Access Compliance Report

Public Rights-of-Way

(Curb Ramps)

Intersection ID: 51323	Main Street: GLENMORE_GARDEN_DR	Cross Street: MCKEE_RD	Location: SW
ADA ID: 2F073D9D1DD5	Ramp Type: Perp	Initial Pass/Fail: Fail	Overall Compliance: No
			Severity Score: 21.25

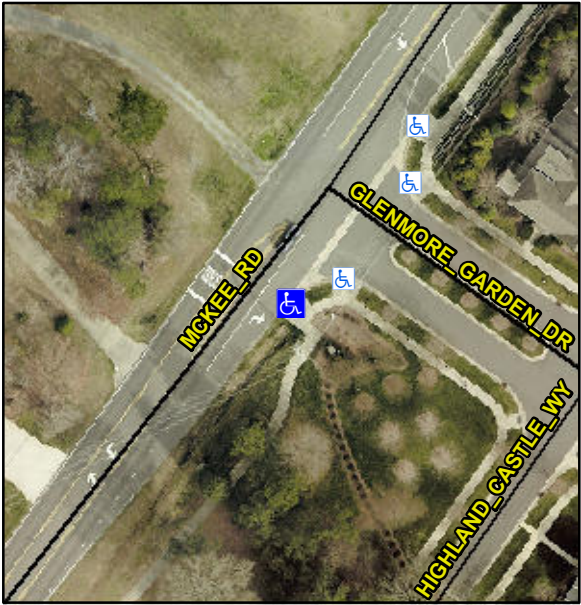
Codes/Mitigation Info/Possible Solution			Field Measurements/Component Compliance		
	Possible Solutions:		Compliance	Description	Data
	Remove & Replace Entire Ramp.		N/A	Ramp Length (in)	102.0
			No	Ramp Width (in)	46.0
			N/A	Flare Type LT	N/A
			N/A	Flare Slope LT (%)	N/A
			N/A	Flare Traversable LT?	N/A
			N/A	Landing Length (in)	N/A
			N/A	Landing Width (in)	N/A
			N/A	Landing Slope (%)	N/A
			N/A	Landing X Slope (%)	N/A
<p>Surveyor Notes:</p> <p>N/A</p> <p>PROW/ADA:</p> <p>R304.5.1, R304.2.2</p>			N/A	Flare Type RT	N/A
			N/A	Flare Slope RT (%)	N/A
			N/A	Flare Traversable RT?	N/A
			N/A	DWS Provided?	N/A
			N/A	DWS Contrast?	N/A
			N/A	DWS Length (in)	N/A
			N/A	DWS Full Width?	N/A
			N/A	DWS Offset (in)	N/A
			N/A	Shared Landing?	N/A
			N/A	Gutter Ponding?	N/A
			N/A	Gutter Lip Ht (in)	N/A
			N/A	Painted X Walk1?	No
				X Walk 1 Direction	To NW
			N/A	X Walk 1 Width (in)	N/A
				X Walk 1 Slope (%)	1.2
				X Walk 1 X Slope (%)	0.9

N/A	Ramp inside XWalk1?	N/A
				Road Slope (%)	N/A
				Road X Slope (%)	N/A
			N/A	Any Obstructions?	N/A
				Obstruction Type	
			N/A		N/A
			Yes	Surface Condition? (G/P)	Good
